# UNITED STATES PATENT AND TRADEMARK OFFICE

APPLICATION NO.	FILING DATE	FIRST NAMED INVENTOR	ATTORNEY DOCKET NO.	CONFIRMATION NO.
10/821,737	04/09/2004	Jochen Schweinbenz	10191/3610	1521
26646 7590 12/22/2006 KENYON & KENYON LLP ONE BROADWAY NEW YORK, NY 10004			EXAMINER PAPE, ZACHARY	
			ART UNIT	PAPER NUMBER
			2835

# Office Action Summary

## DETAILED ACTION

Fig 1

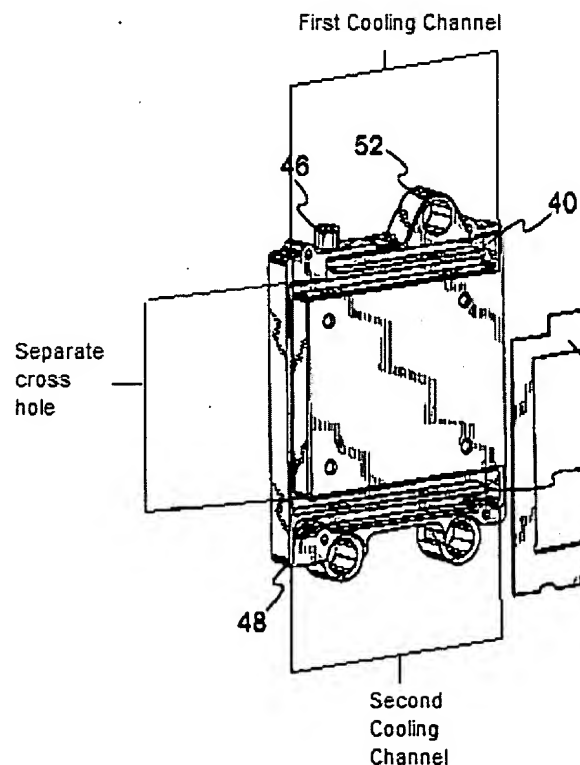
With respect to claim 9, Clamp et al. further teaches that the cooling plate has separate cooling channels (As illustrated in Fig 2, the first cooling channel is located near 40 and a second, separate cooling channel is located near 44).

With respect to claim 10, Clamp et al. further illustrates that the separate cooling channels are connected by at least one separate cross hole (Running along the left side of the bottom as illustrated in Fig 2 and present office action Fig 1 below).
